Road Safety Audit Report

Incorporating
Stage 1 Completion of Preliminary Design

Proposed Development Access off the A259 New Road, Rustington

Job no	RSA-16-069	Issue no	1	Date	January 2017
Prepared by	JJF	Verified by	AJB	Approved by	JJF
Filename and Path	Fenley/Road Safety Audits/RSA-16/RSA-16-069-1

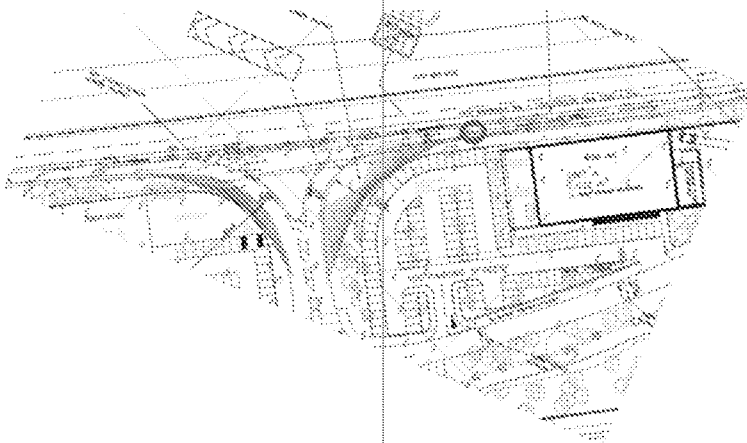
Audit Item No.	Audit Team Observation	Audit Team Recommendation	Design Team / Scheme Response
A.1	GENERAL		
A.1.1	PROBLEM <i>Inadequate weaving length</i> Accident Type <i>Side swipes / rear end shunts</i> Location <i>East of proposed deceleration lane</i> It was apparent from the site visit that the recently constructed acceleration lane associated with the adjacent development to the east, merges with the A259 channel line approximately 40 metres to the east of the proposed deceleration lane. Therefore vehicles exiting the adjacent development will be in conflict with vehicles entering the proposed development which are likely to be changing lanes simultaneously. This may result in side swipes and shunts along the recently constructed acceleration lane where vehicles are not able to merge onto the A259 from the adjacent development. 	It is recommended that the weaving length is increased appropriately.	Refer to Redwood Partnership response dated 15th March 2017, Ref 3167D5
